<b>Title - Sujet</b> CCTV VIDEO MONITORING SYSTEM	
<b>Solicitation No. - N° de l'invitation</b> 47504-146170/A	<b>Amendment No. - N° modif.</b> 001
<b>Client Reference No. - N° de référence du client</b> 1000316170	<b>Date</b> 2013-10-22
<b>GETS Reference No. - N° de référence de SEAG</b> PW-\$\$HN-442-63476	
<b>File No. - N° de dossier</b> hn442.47504-146170	<b>CCC No./N° CCC - FMS No./N° VME</b>
<b>Solicitation Closes - L'invitation prend fin</b> <b>at - à 02:00 PM</b> <b>on - le 2013-10-30</b>	
<b>Time Zone</b> <b>Fuseau horaire</b> Eastern Daylight Saving Time EDT	
<b>F.O.B. - F.A.B.</b> <b>Plant-Usine:</b> <input type="checkbox"/> <b>Destination:</b> <input checked="" type="checkbox"/> <b>Other-Autre:</b> <input type="checkbox"/>	
<b>Address Enquiries to: - Adresser toutes questions à:</b> Hamel, Jean-Yves	<b>Buyer Id - Id de l'acheteur</b> hn442
<b>Telephone No. - N° de téléphone</b> (819) 956-8278 ( )	<b>FAX No. - N° de FAX</b> ( ) -

## **Amendment 001**

Amendment 001 is raised to provide the Mandatory Site Visit minutes and answers to bidder questions.

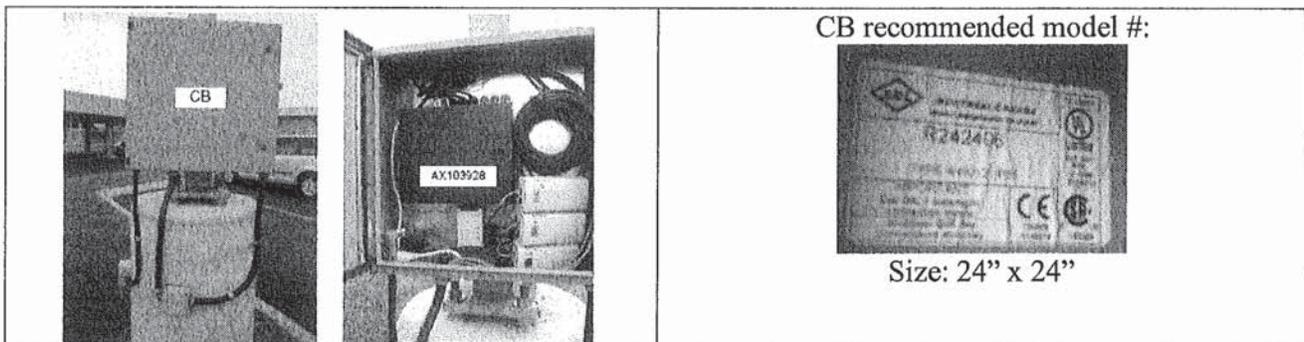
- 2.9. Cameras 1,2,3 and 6 should be terminated within an enclosure resembling the following:
